Blessington eGreenway

Response to ABP Submissions

Project number: 60617025

Wicklow County Council

Figure 2.2 Tree Planting at Knockieran

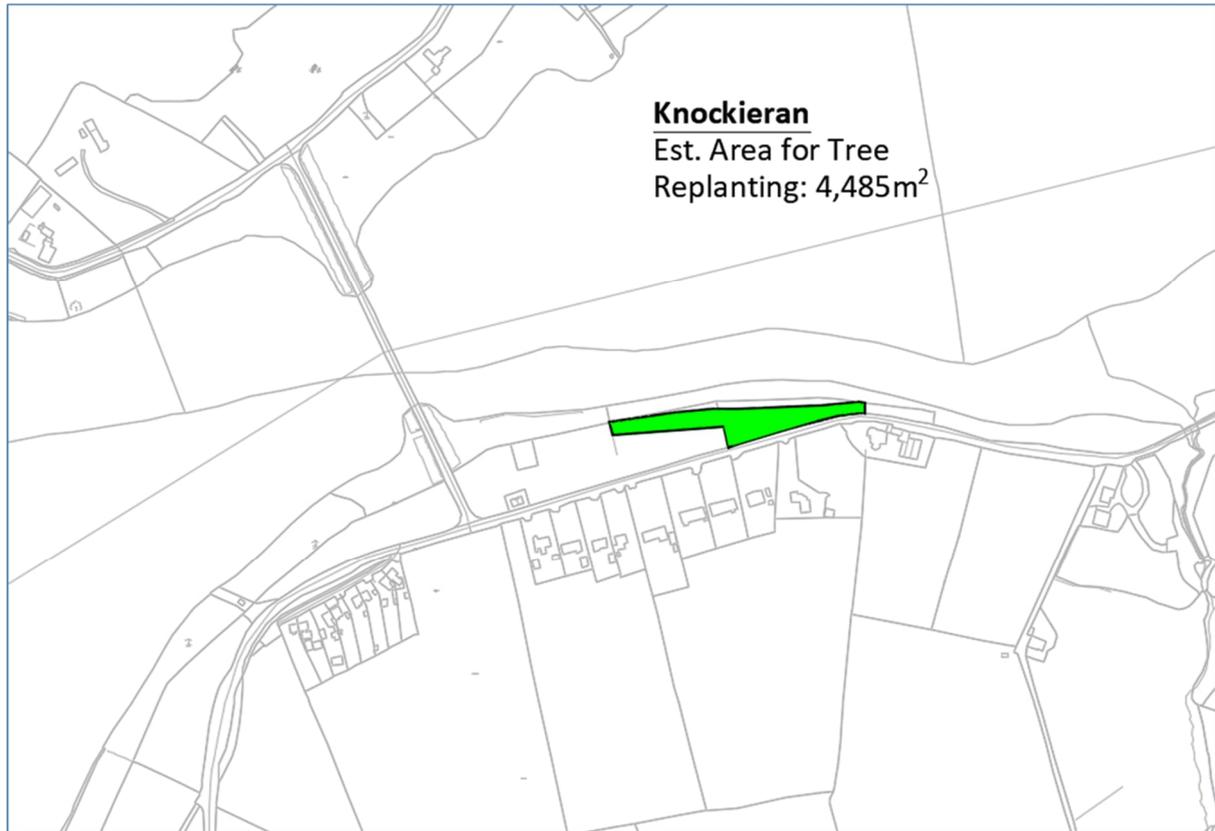
The submissions relating to trees refer to the number of trees to be removed because of the project and the impact this will have on wildlife and the environment.

Wicklow County Council has identified other parcels of land in their ownership that directly adjacent to or close to the Blessington eGreenway which are suitable for replanting purposed and has given the commitment to replant these areas with native species trees. This would result in the planting of approximately 4,965 trees as outlined in Table 2.6.2. See Figure 2.2, 2.3, 2.4, 2.5, 2.6

Location	No. of Trees per 100 Square meters (m2)	Area (m2)	Estimated No. of Trees for Replanting
Knockieran	25	4,490	1,122
Burgage	25	3,025	756
The Avon (Area 1)	25	5,500	1,375
The Avon (Area 2)	25	6,850	1,712
Totals		19,860	4,965

SHEET NUMBER
 60617025_SHT_DD_BLGWY_101.1

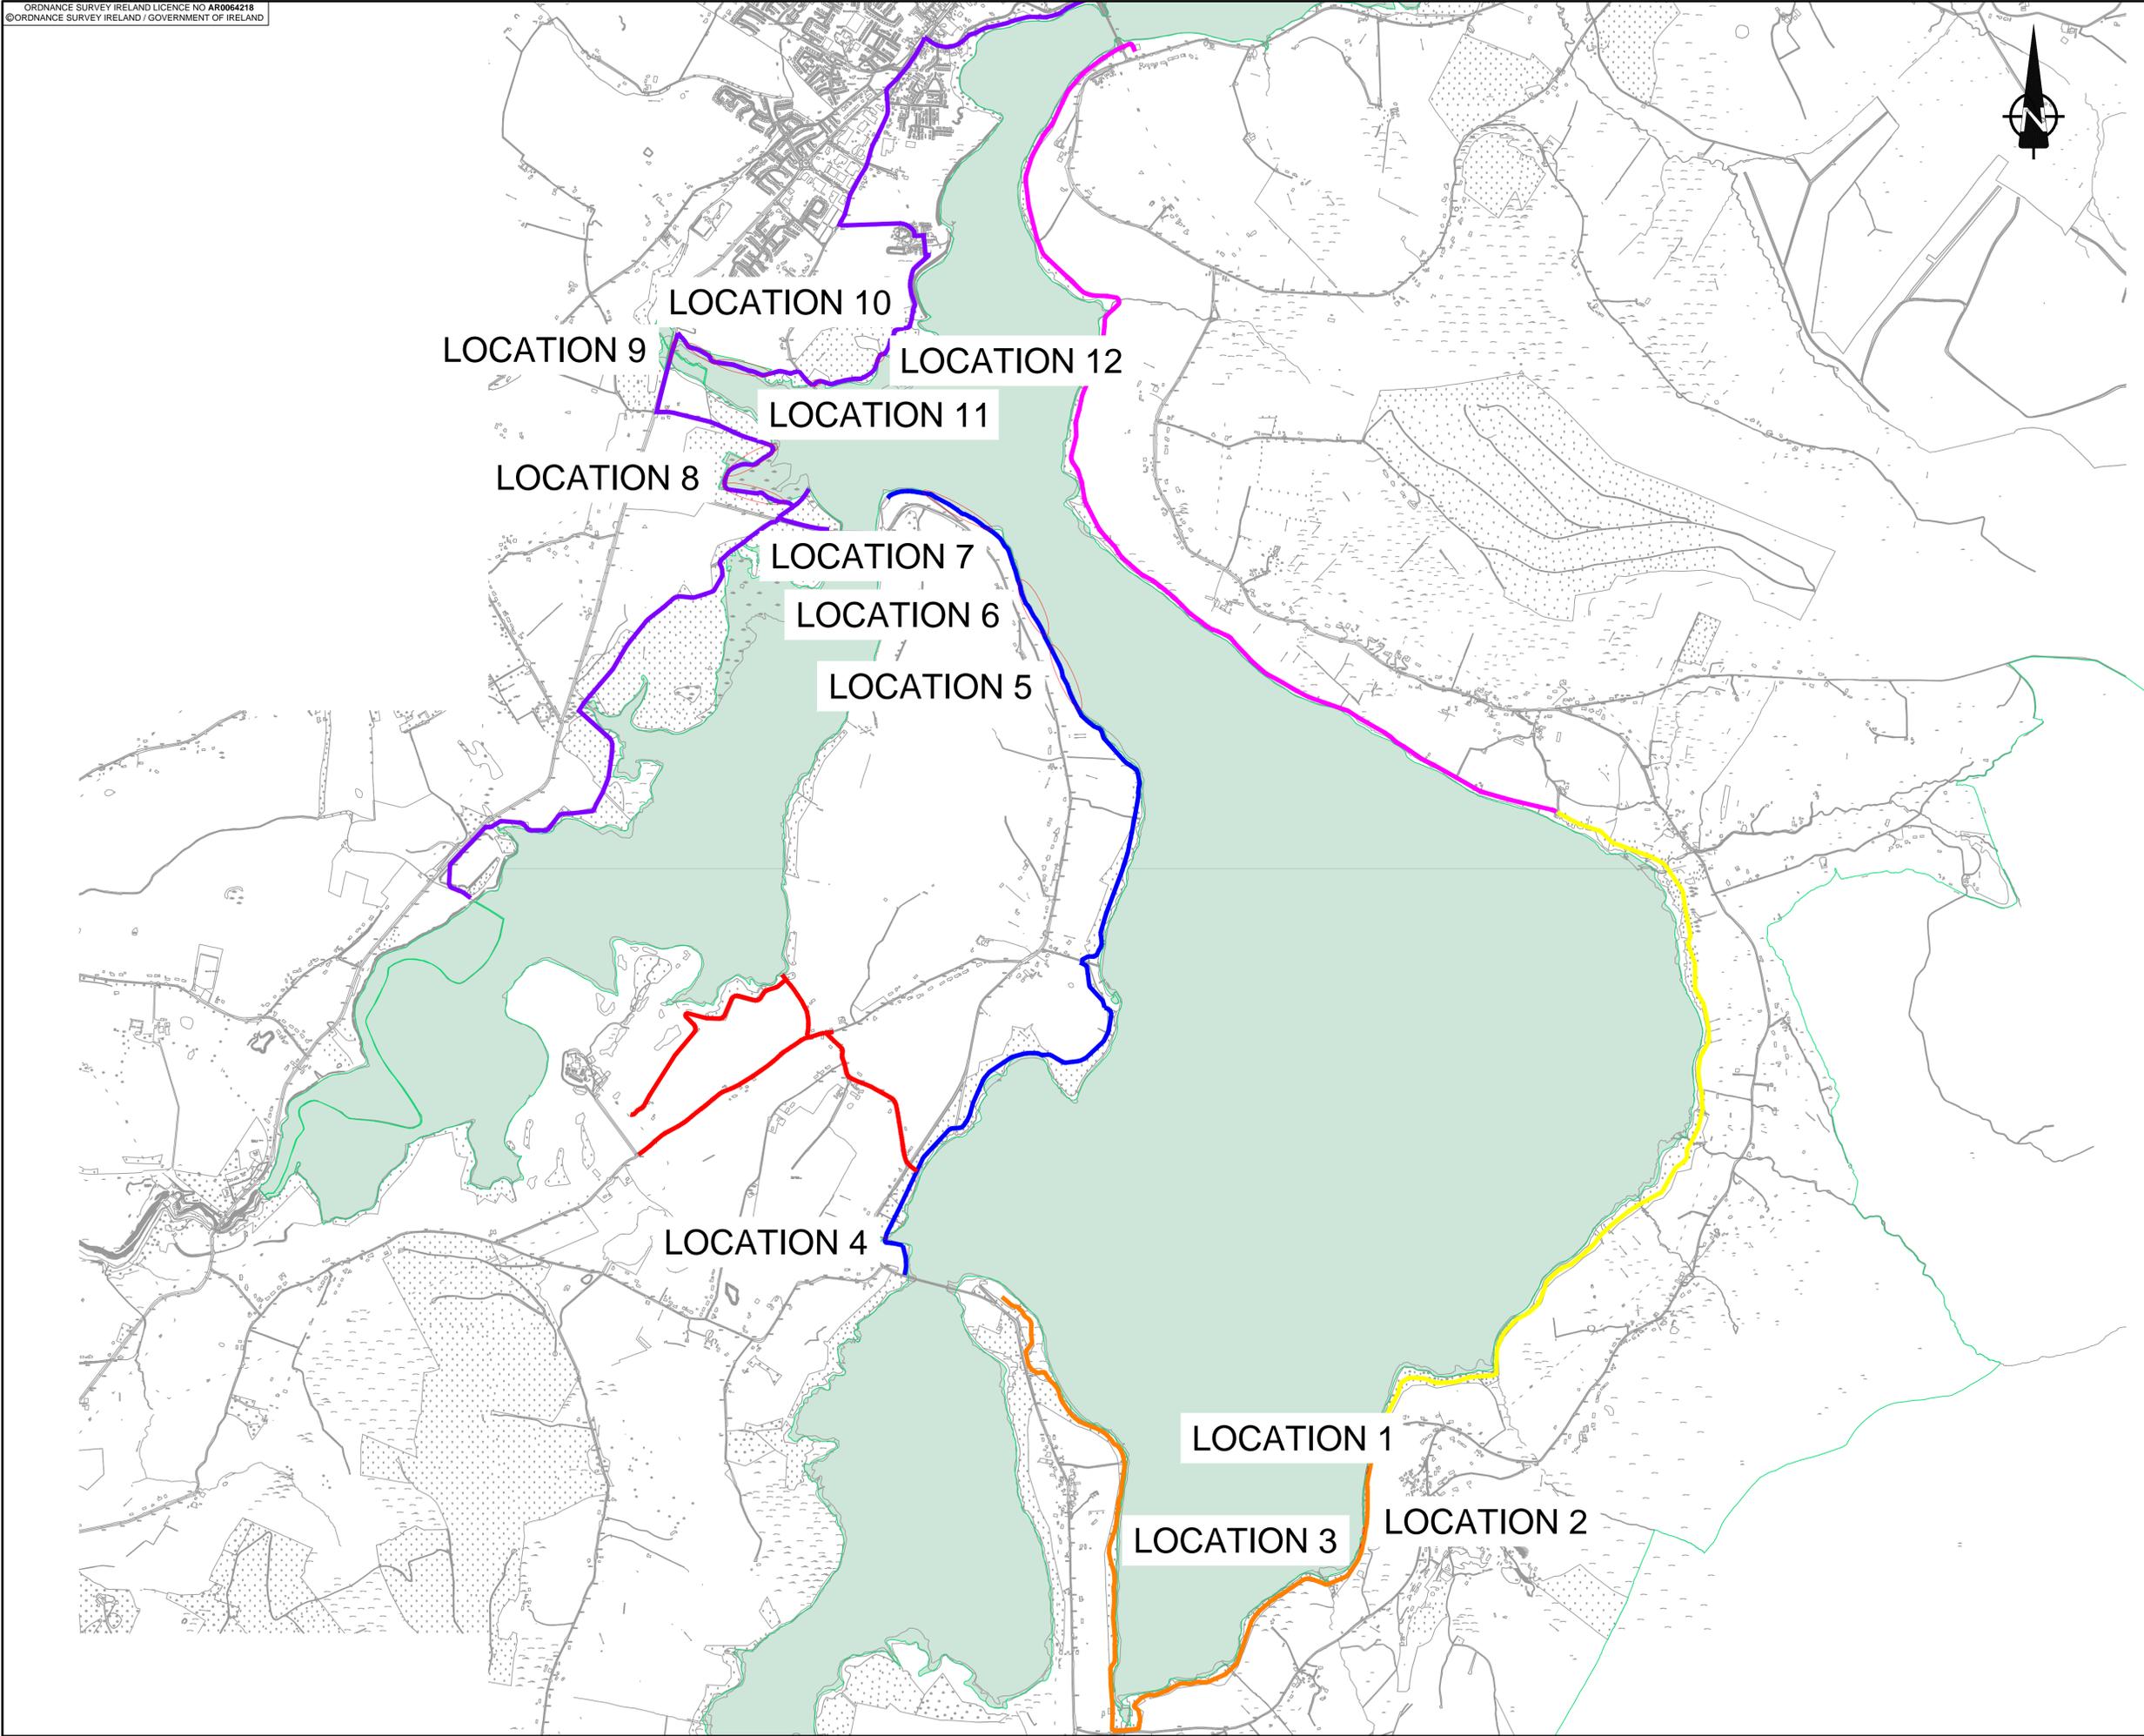
There is no definitive line on any of the submitted drawings to indicate the boundary of the SPA. It is therefore impossible to tell where the proposed eGreenway encroaches on the SPA. The Proposed Development will encroach on and into the Special Protection Area this is conceded on Page 31 of the Ecological Impact Assessment report which forms part of the application. See Table 2, Page 31. EIA Report. Distance to designated Site. The nature and extent of the encroachment is impossible to calculate from the information provided in the application document.

The existing Blessington Greenway involves encroachment into the Special Protection Area. The Proposed Development involves encroachment into the Special Protection Area. This is required to provide erosion protection measures, water crossing facilities and to minimise the loss of trees. The encroachment is identified on drawings:

- 60617025_SHT_DD_BLGWY_101.1
- 60617025_SHT_DD_BLGWY_150.1,
- 60617025_SHT_DD_BLGWY_150.2,
- 60617025_SHT_DD_BLGWY_150.3,
- 60617025_SHT_DD_BLGWY_150.4.

Table 1. Encroachment into SPA (Refer to drawing numbers above for locations)

Location No.	Area (m²)	Comment
1	1297	Erosion protection
2	496	Erosion protection
3	2340	Erosion protection
4	265	Water crossing
5	300	Erosion protection
6	3491	Erosion protection
7	16	Erosion protection
8	62	Routing to for reduced tree impact
9	15	Location of existing facility
10	379	Location of existing facility
11	1375	Location of existing facility
12	109	Location of existing facility
